World Forum for Harmonization of Vehicle Regulations**Working Party on Passive Safety****Sixty-ninth session**

Geneva, 17-21 May 2021

UN Regulation No. 135 (Pole Side Impact (PSI))**Proposal for Supplement 3 to the 01 series of amendments to
UN Regulation No. 135 (Pole Side Impact (PSI))****Submitted by the experts from Germany ***

Paragraph 1.1. (b), amend to read:

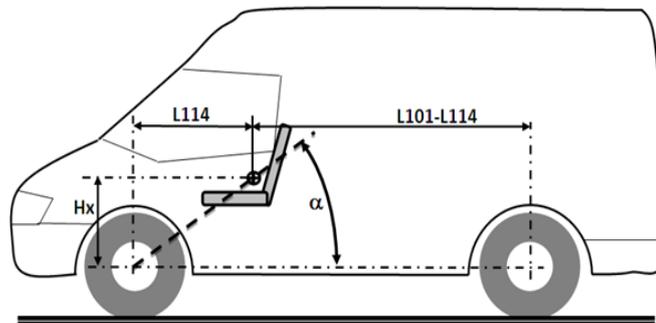
- (a) Category M₁ vehicles with a gross vehicle mass of up to 3,500 kg; and
- (b) Category N₁ vehicles where, **when positioned on a level surface with all tyres inflated as recommended by the vehicle manufacturer and loaded to the unladen vehicle mass as defined in paragraph 2.24.**, the acute angle alpha (α), measured, between a horizontal plane passing through the centre of the front axle and an angular transverse plane passing through the centre of the front axle and the R-point of the driver's seat, as illustrated below, is less than 22.0 degrees; or the ratio between the distance from the driver's R-point to the centre of the rear axle (L101-L114) and the centre of the front axle and the driver's R-point (L114) is less than 1.30.²

2. The measurement of this angle in paragraph 1.1. of UN Regulation No. 135, 01 series of amendments, may vary depending on the surface on which the vehicle is placed, the tire pressure and the loading status of the vehicle. The proposed amendment defines these parameters to enable a reproducible measurement of the acute angle alpha (α) to establish whether a vehicle is into the scope of UN Regulation No. 135.
